## **WICA Audit Report to IPART**

### **Licence Plan Audit (Sewerage)**

### **Aquacell (Kurrajong)**

Licence No. 15\_032: Aquacell Pty Ltd

Figure A3.4 SCADA mimic

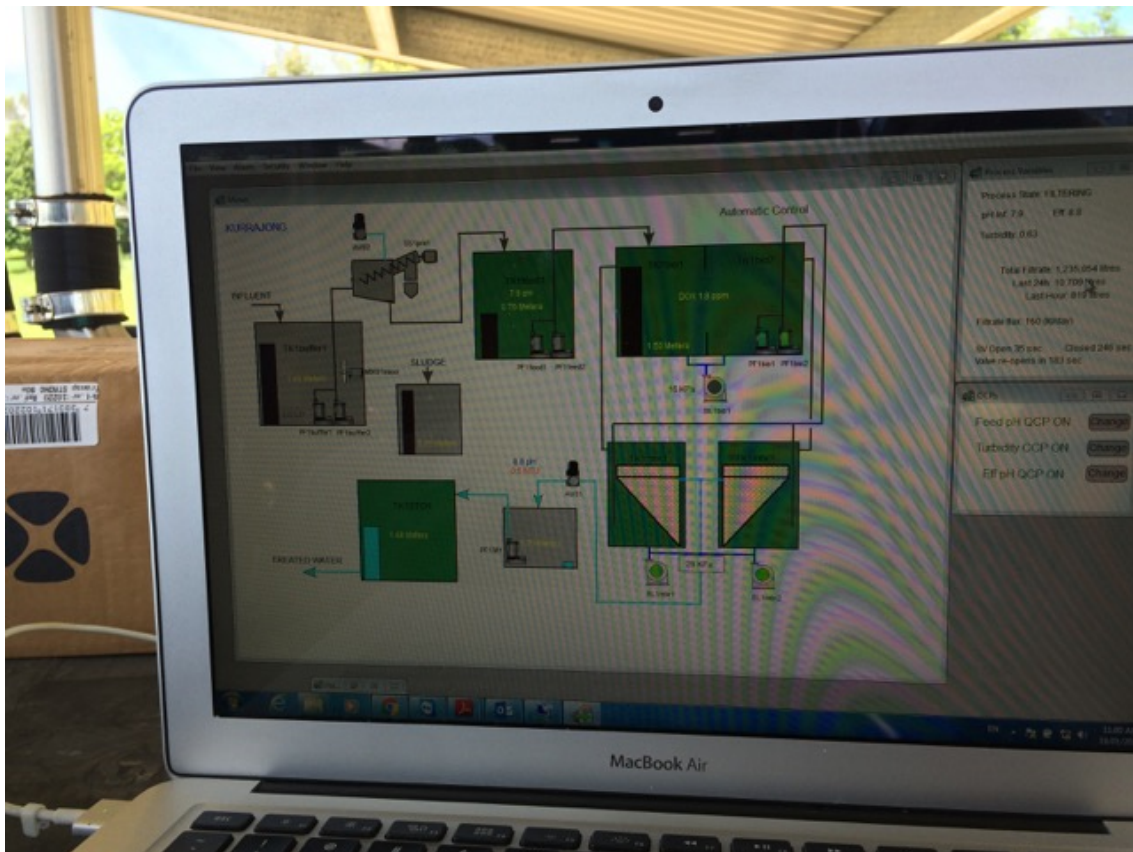
The treatment plant on-line monitoring was operating appropriately during the site inspection. The instruments had been protected under cover which is a good initiative (Figure A3.3). The SCADA mimic was seen at the site and the instruments were displaying on both the SCADA and their own readouts (Figure A3.4). The turbidity reading was recording 0.64 on the SCADA display and on the instrument display, suggesting that the SCADA system had been scaled precisely. During the audit the line from the SCADA to head office was down and this needs to be rectified (refer also to discussion in Table A1.1).
